SUBDIVISION REVIEW SHEET

CASE NO.: C8-2019-0114 **PC DATE:** April 28, 2020

SUBDIVISION NAME: Simon-Caskey Tract Preliminary Plan

LITTLE DEER XING AND SILVERMINE INTERSECTION.

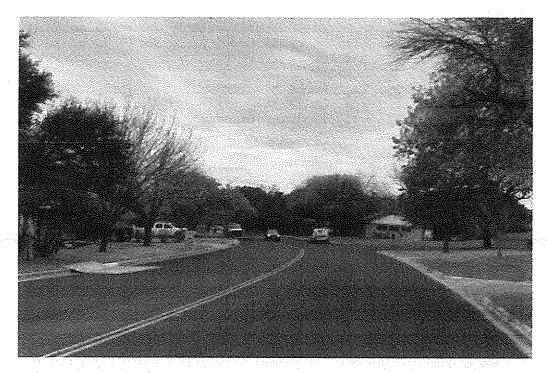
SILVERMINE HAS BECOME A MAJOR CUT THROUGH FROM HWY 71 TO HWY 290 TO AVOID THE Y INTERSECTION

SCENIC BROOK DR.

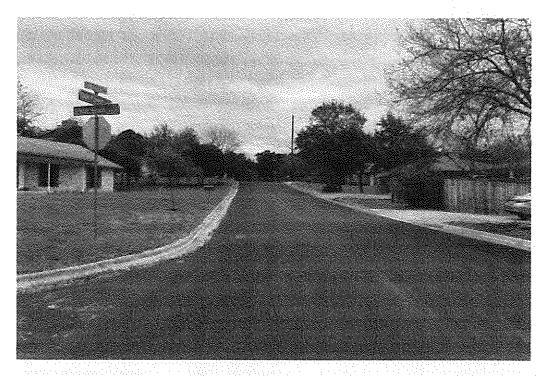
THIS IS A VERY WIDE TWO-LANE ROAD WITH CURBS AND SIDEWALKS IN SOME AREAS

OAK FOREST LANE

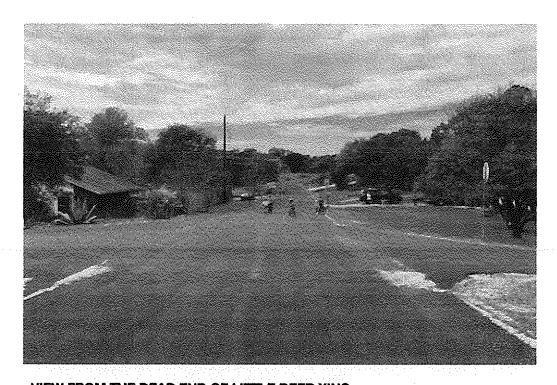
THIS ROAD IS A WIDE ROAD WITH CURBS THAT COULD ACCOMMODATE A CUL-DE-SAC RATHER THAN IT GOING THROUGH AND CONNECTING WITH LITTLE DEER XING

VIEW FROM THE DEAD END OF LITTLE DEER XING

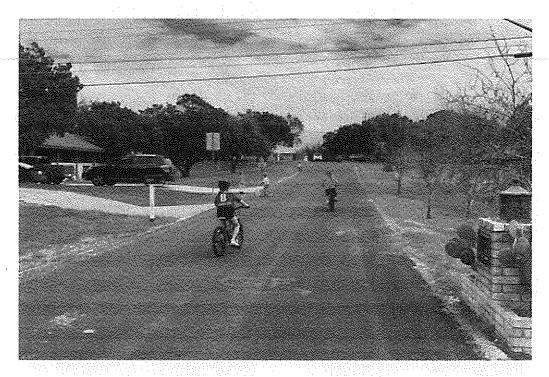
VERY NARROW STREETS, NO CURBS, LOTS OF HILLS AND LOTS OF KIDS

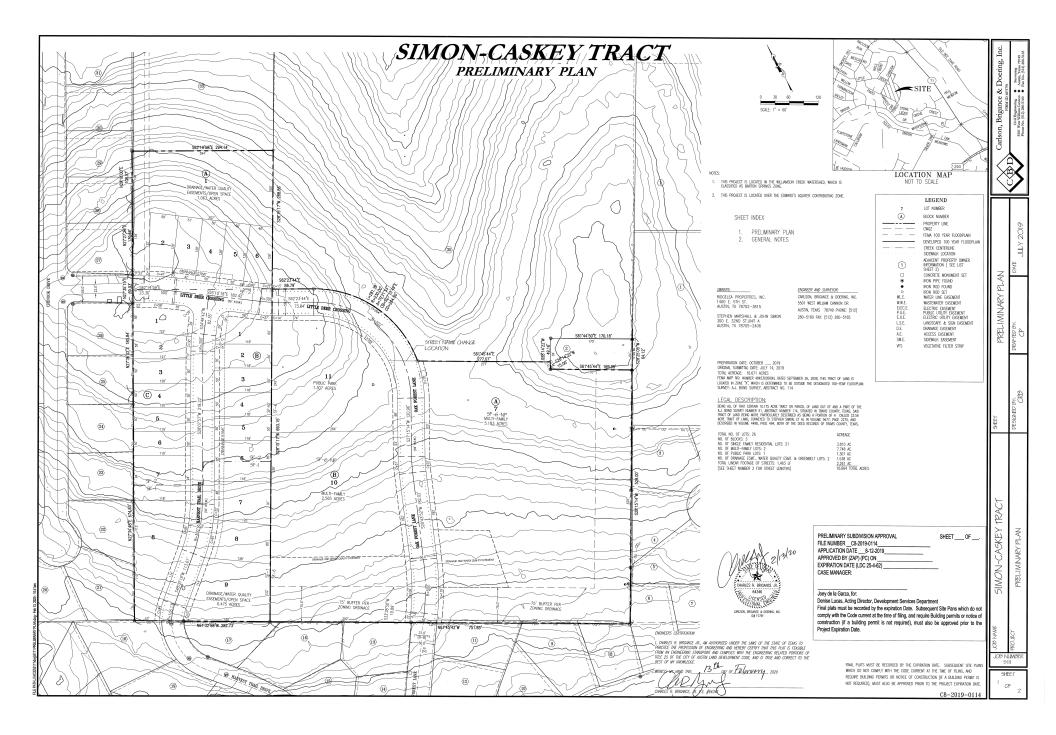
VIEW LOOKING TO THE DEAD END OF LITTLE DEER XING (THE WHITE TRUCK IS PARKED AT THE DEAD END) WHERE IT'S BEING PROPOSED TO CONTINUE TO MEET WITH OAK FOREST LANE
